Addendum Addenda

No./No
2

Project Description / Description de projet		
SAS-01 Roof Replacement 000 Block/SAS-01 Replacement Du Toit 000 Bloc		
Project No./No de projet	Departmental Representative / représentant ministériel	Date
6119	Jazmin McLean	25-May-2022
Solicitation No./N° de sollicitation		
22-58003		
<p>Notice: This addendum shall form part of the tender documents and all conditions shall apply and be read in conjunction with the original plans and specifications.</p>		
<p>Nota: Cet addenda fait partie intégrale des dossiers d'appel; toutes les conditions énoncées doivent être lues et appliquées en conjonction avec les plans et les devis originaux.</p>

Project Name:	National Research Council Roof Replacement	Date:	May 16, 2022
Project Address:	110 Gymnasium Place, Saskatoon, Saskatchewan	Client Name:	National Research Council of Canada
Project Location:	Roof	Client Project/P.O. No.:	6119
Client Contact:	Jazmin McLean	Pinchin File No.:	300068.000
Pinchin Project Manager:	Michael Evanyshyn	Delivery Method:	Email

drawing
PLUMBING VENT DETAIL
 dessin

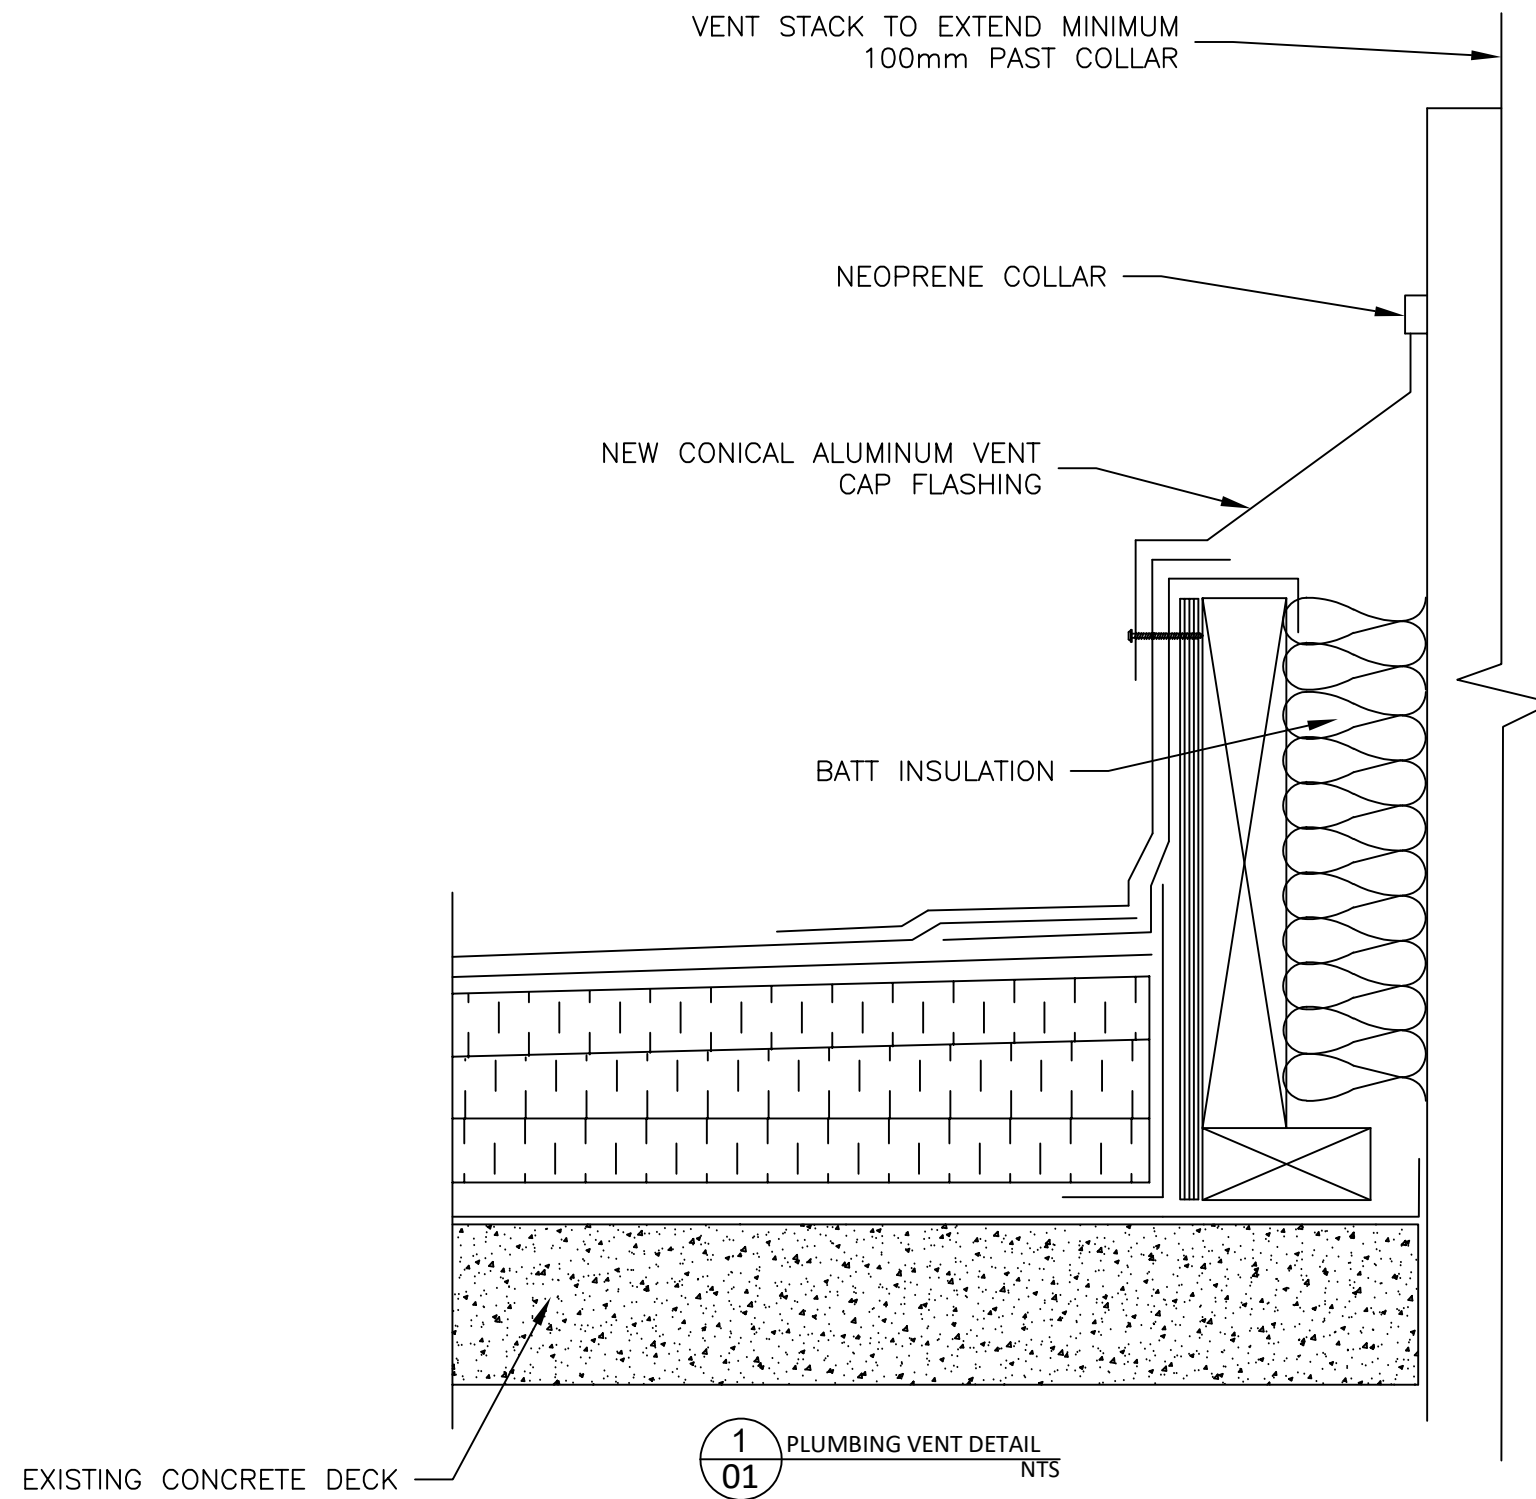
Q: What type of plumbing vent is acceptable for use?

A: Refer to detail SK01 included in this addendum.

drawing
ROOF TO MASONRY WALL DETAIL

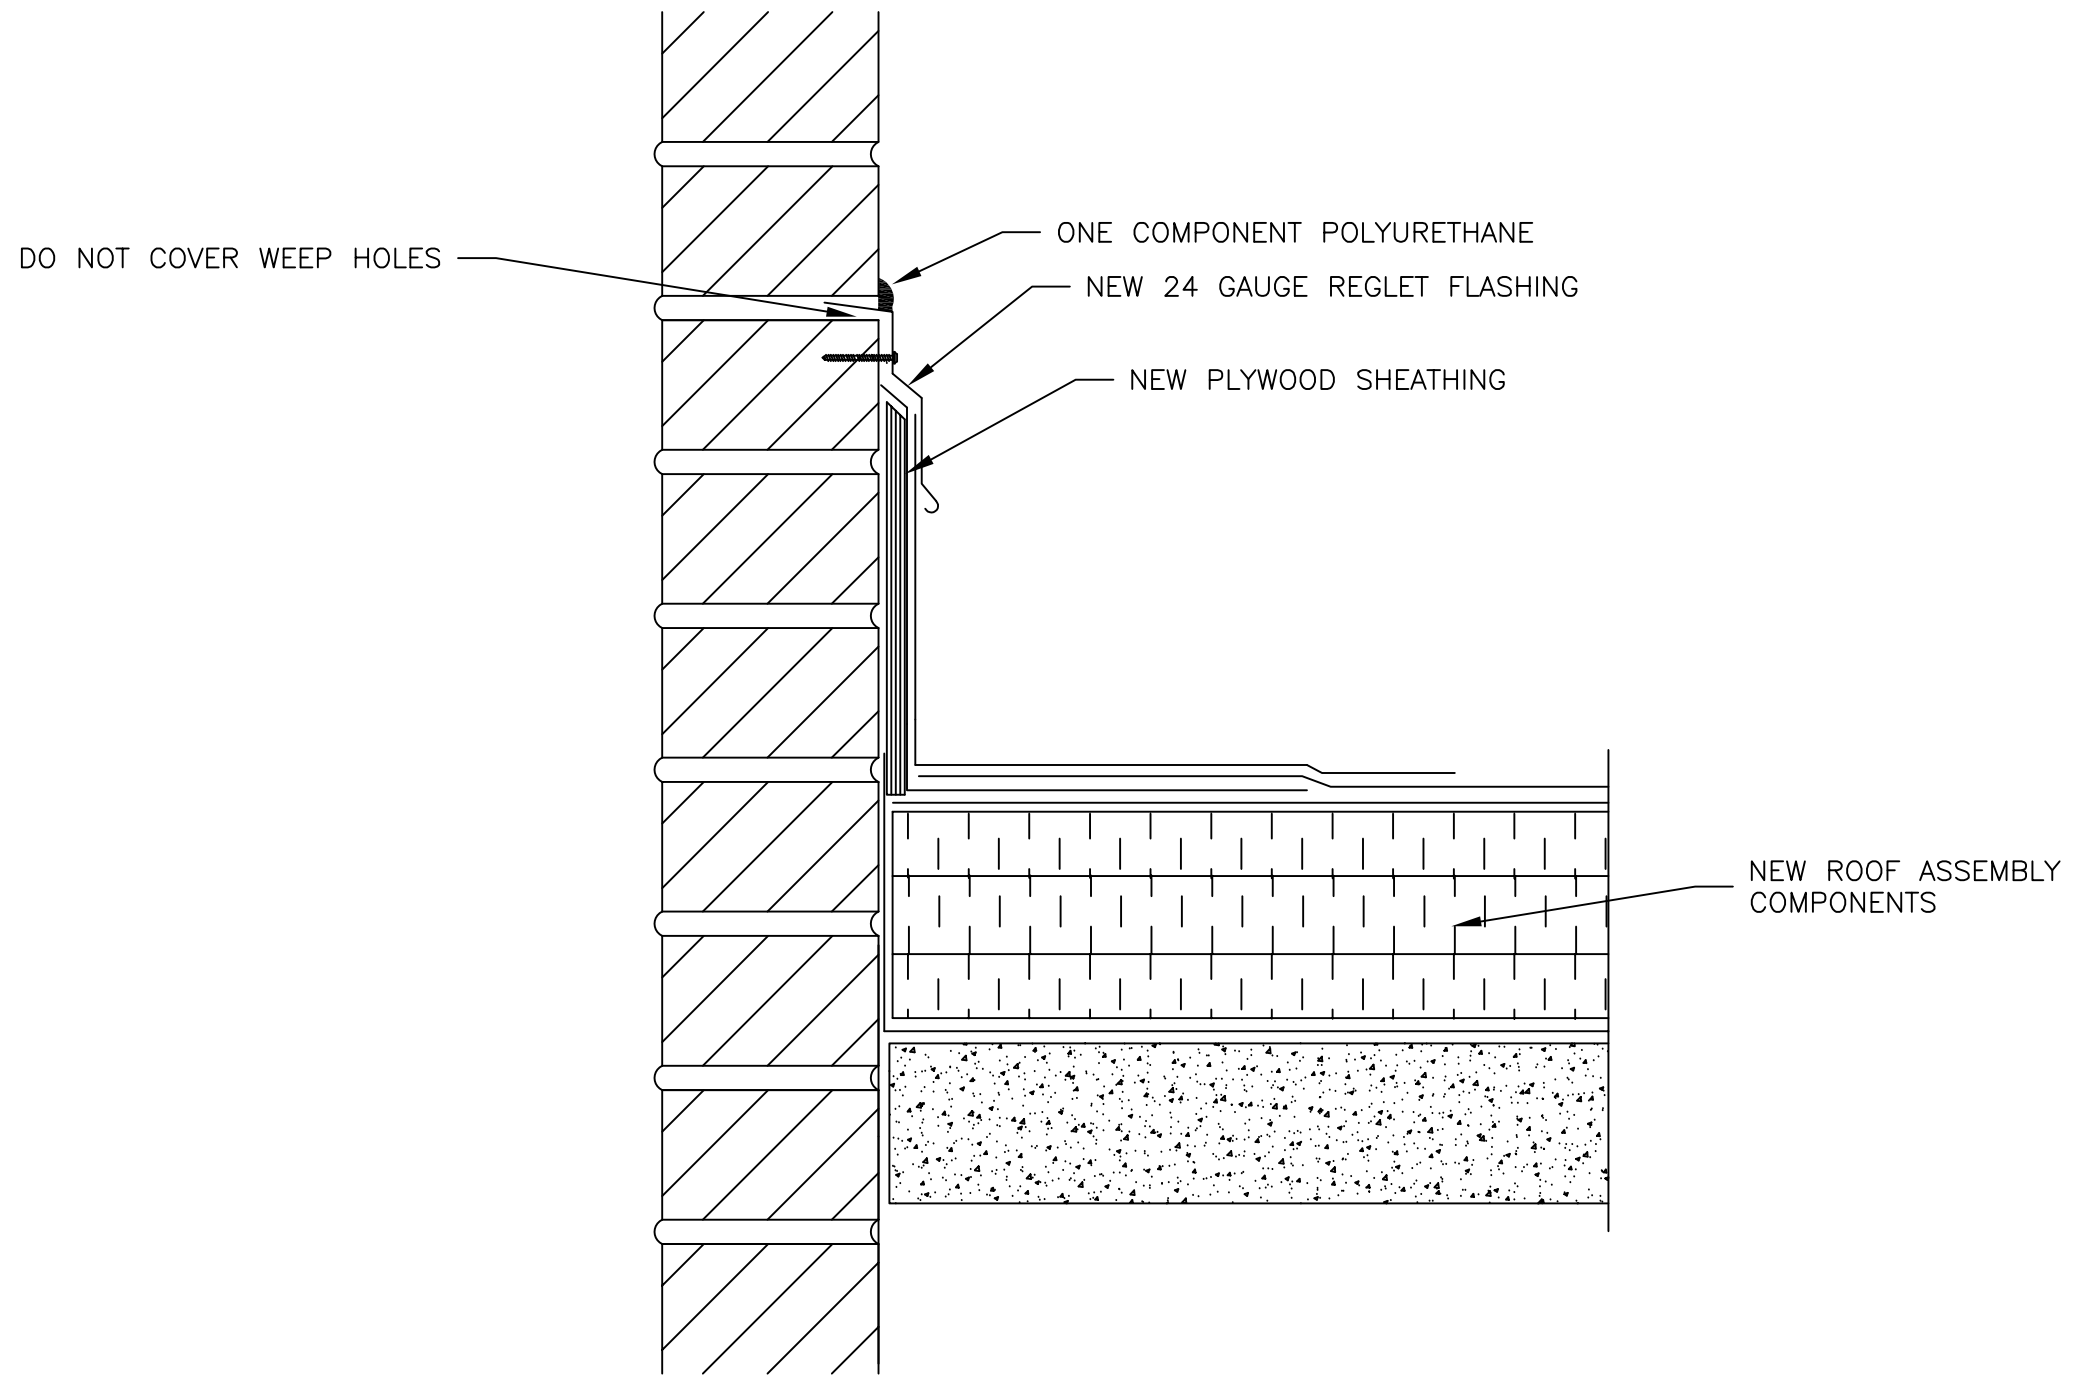
Q: No details provided for high low cladding walls. Can detail be provided?

Q: No detail provided at high low walls brick locations. Can detail be provided?

A: Refer to detail SK02 included in this addendum.

A: Refer to detail SK02 included in this addendum.
